Geologic and Geotechnical Review of Storm Drain Plans
Parcel Map No. 062646, MTD No1843
Santa Clarita, California

September 14, 2011 W.O. 6457

Subject: **Geologic and Geotechnical Review of Storm Drain Plans, Parcel Map No. 062646, MTD No. 1843, Santa Clarita, California**

REVISED
PLATE 1D

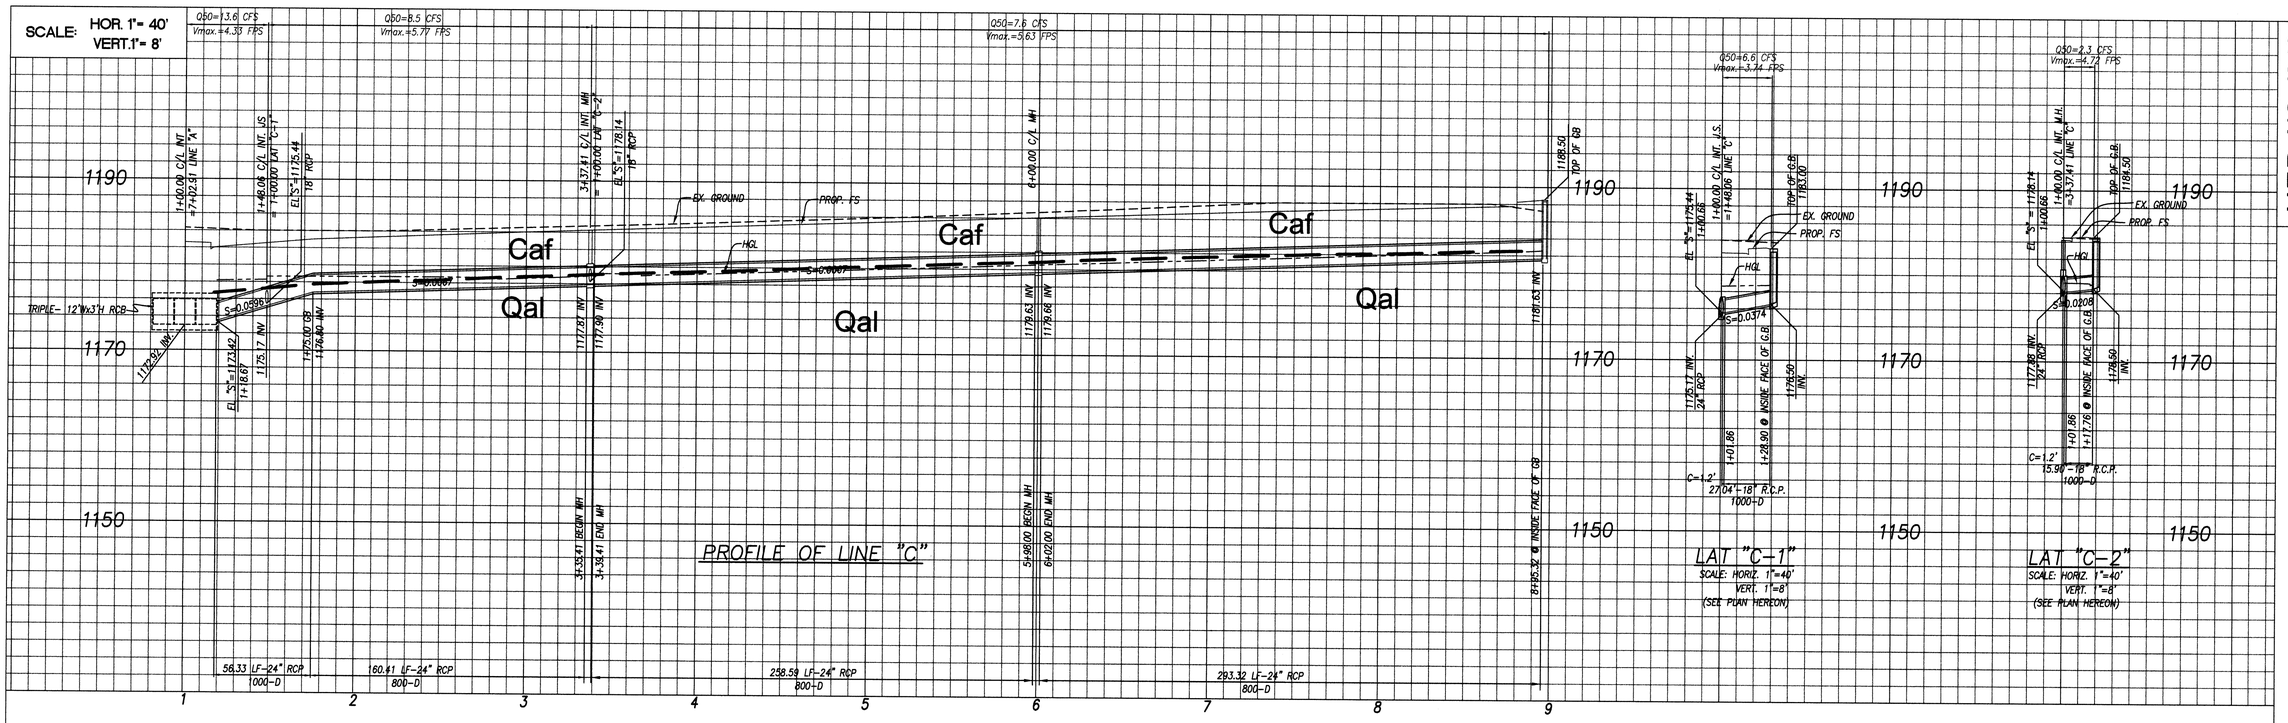
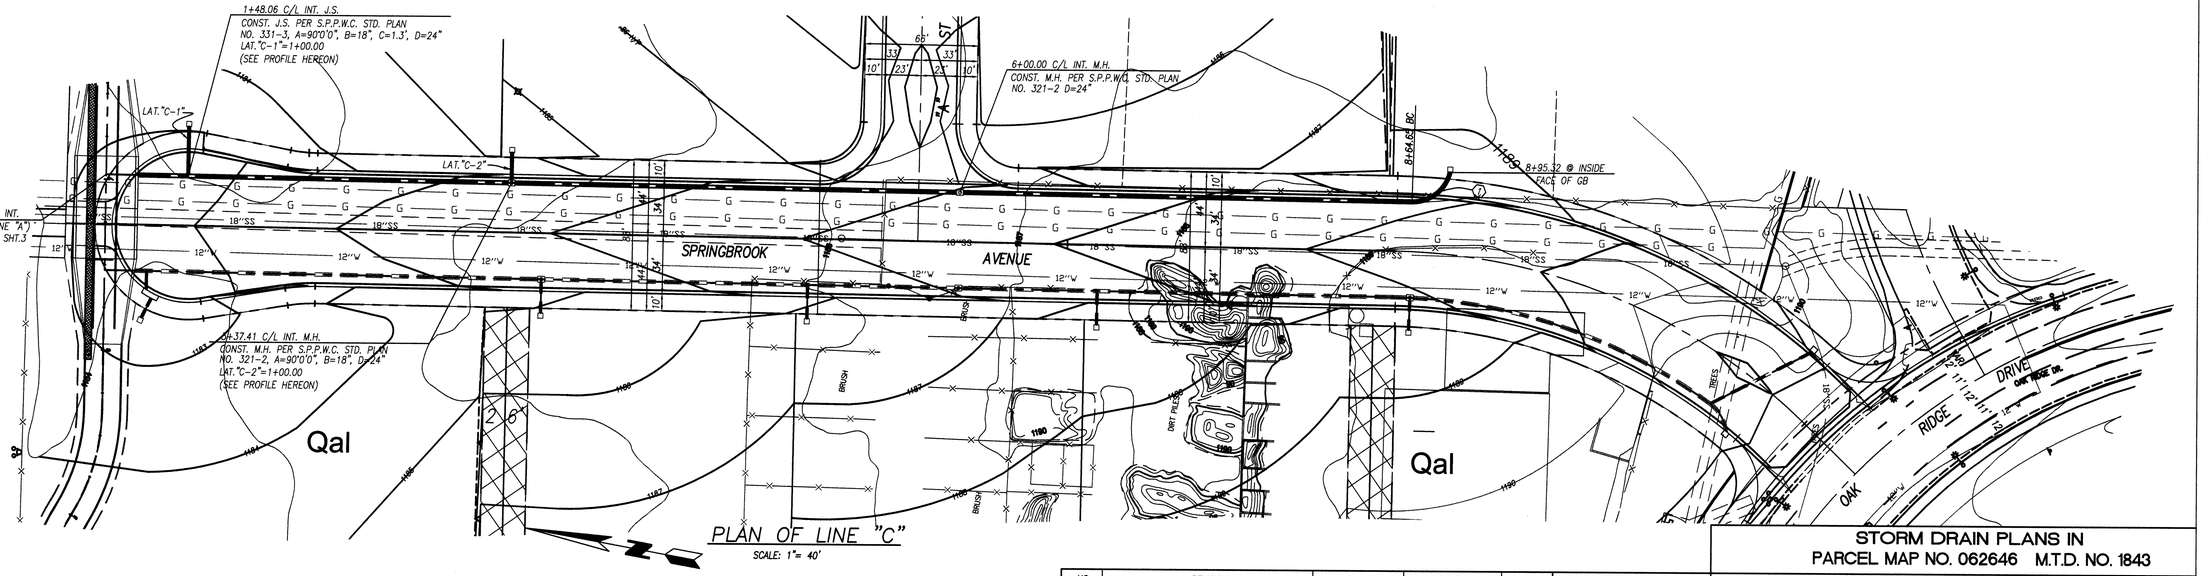
Where a transition is present below storm drain pipes, the rubber gasket locations are shown on the plans (Plate 1E). A transition is also located below the box culvert on Plate 1D. Due to the gradual transition and similar characteristics of the proposed fill and existing alluvium, below the box culvert, differential settlement is considered negligible and therefore, it is our opinion that the box culvert can be constructed as planned.

REVISED | SHEET 3A

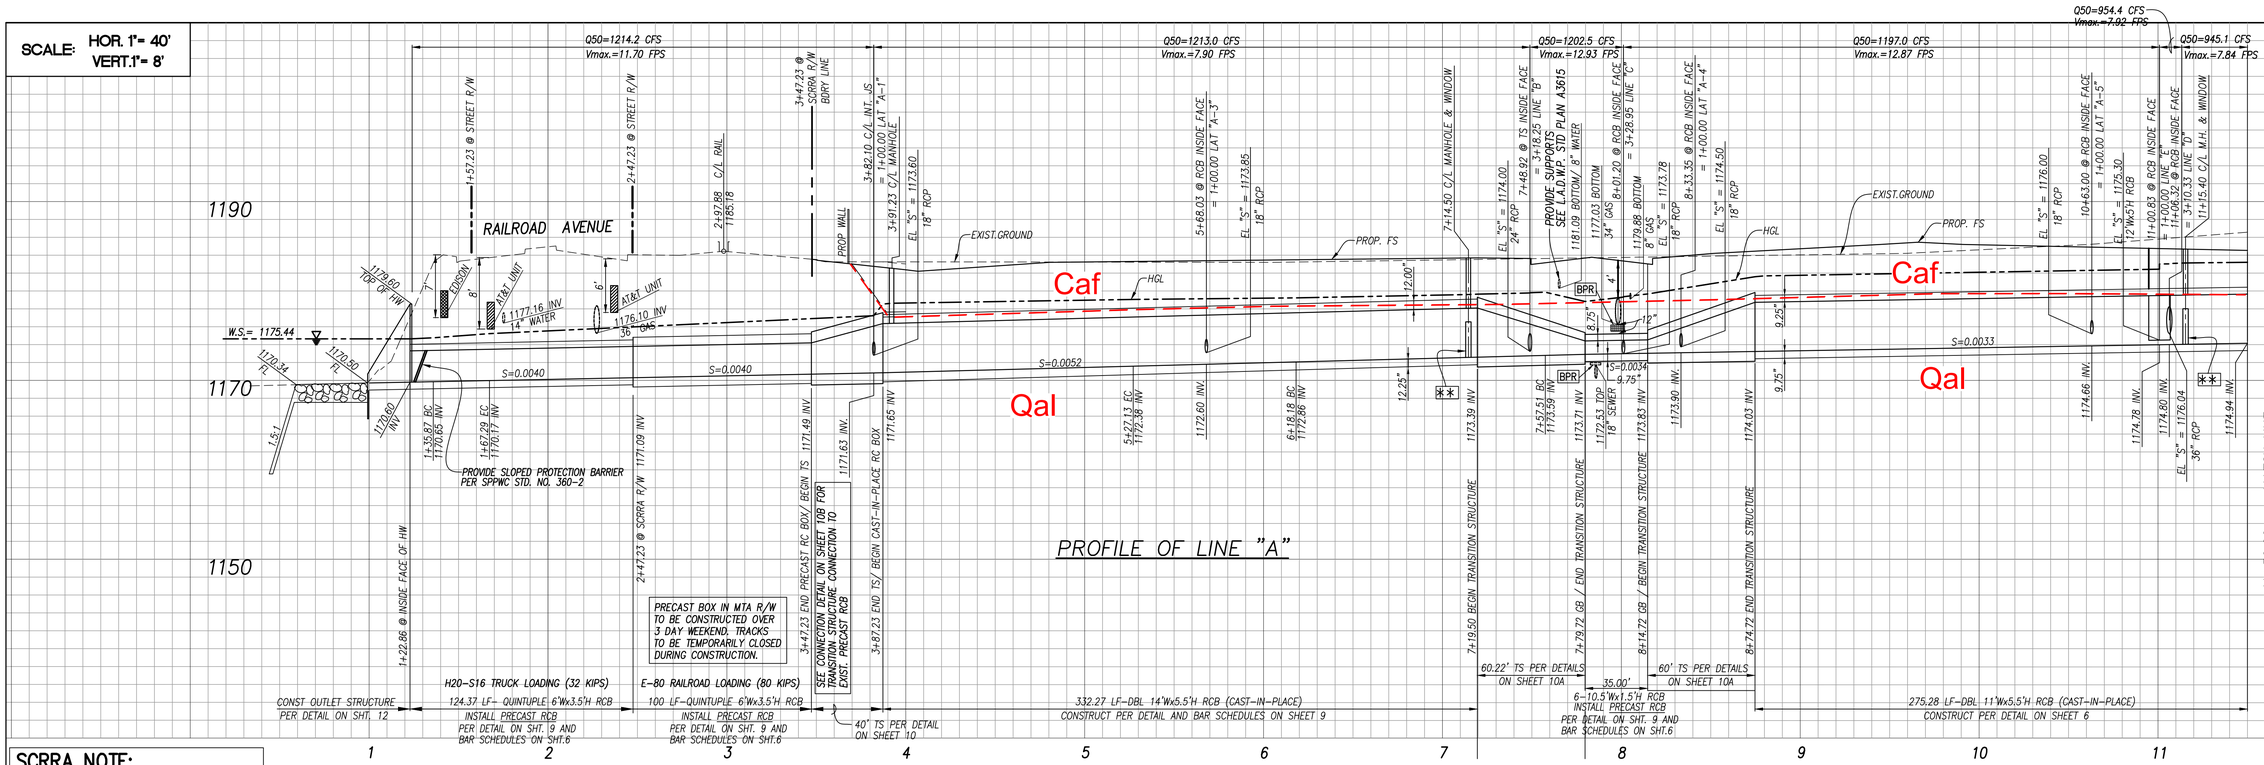
The revisions to the storm drain plans included the realignment of Line "A" in order to avoid a conflict with an existing high pressure gas line. The storm drain sheets that were revised are sheets 3A (Plan and profile line "A" replacing sheet 3) and 4A (plan and profile line "A" and line "E" replacing sheet 4). Detail sheets 10A and 10B and sheet 13A easement exhibit was also revised. Sheet 1 includes the key map depicting the realignment of Line "A".

Information presented in the referenced reports has been utilized to prepare this report. Subsurface exploration results were transferred to sheets 3A and 4A in order to present a revised geotechnical map that shows the soil types along the new alignment of storm drain.
